**Martinsville Board of
Works & Safety
Meeting Agenda
Monday, August 25,
2025
6:30 PM - Council
Chambers**

SECTION 00 63 63 - CHANGE ORDER NO. 3

City of Martinsville, Indiana
Levee Improvements Project
Phase II – South Levee
Change Order No. 3 Justification
June 9, 2025

City of Martinsville, Indiana
Levee Improvements Project
Phase II – South Levee
Change Order No. 4 Justification
August 1, 2025

GRAVEL DRIVE EXHIBIT SOUTH
 MARTINSVILLE SOUTH LEVEE
 CITY OF MARTINSVILLE
 WASHINGTON TOWNSHIP, MARTINSVILLE INDIANA

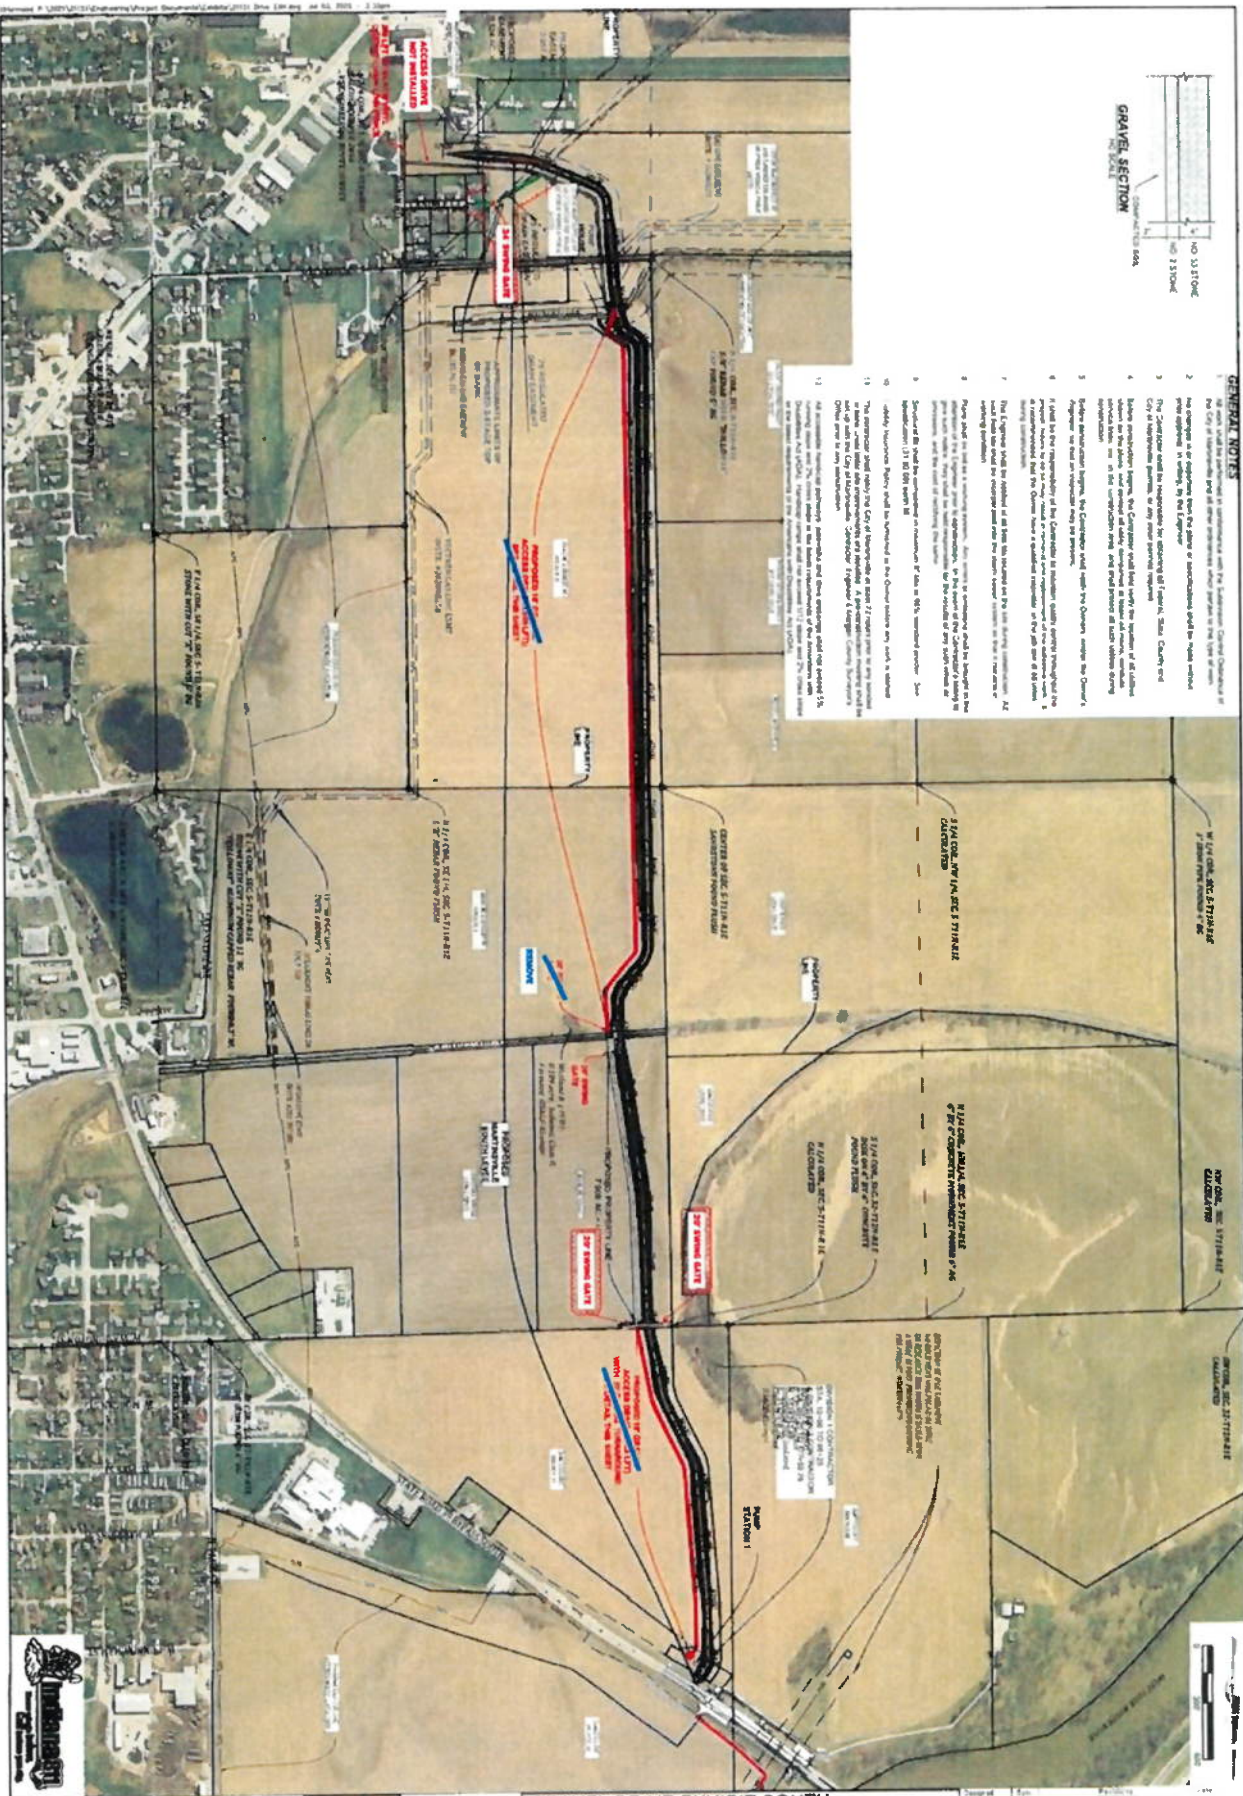
Issue #7 (Access Drive Removal)

The City representative requested that the original proposed access drive off Robin Road be removed upon use. The City requested that the new access drive be relocated off Candice Court. This change order item includes the removal of stone and placement of dirt/fill back in its place. The contractor provided a price for the proposed changes in the amount of \$36,250.00. **The cost adjustment to the contract for this change order item is an increase of \$36,250.00.**

Issue #9 (Candice Court Additional Stone)

The contractor installed a new stone access drive off Candice Court. As previously mentioned, the original access drive off Robin Road was removed and relocated. The contractor provided a price for the additional stone in the amount of \$6,500.00. **The cost adjustment to the contract for this change order item is an increase of \$6,500.00.**
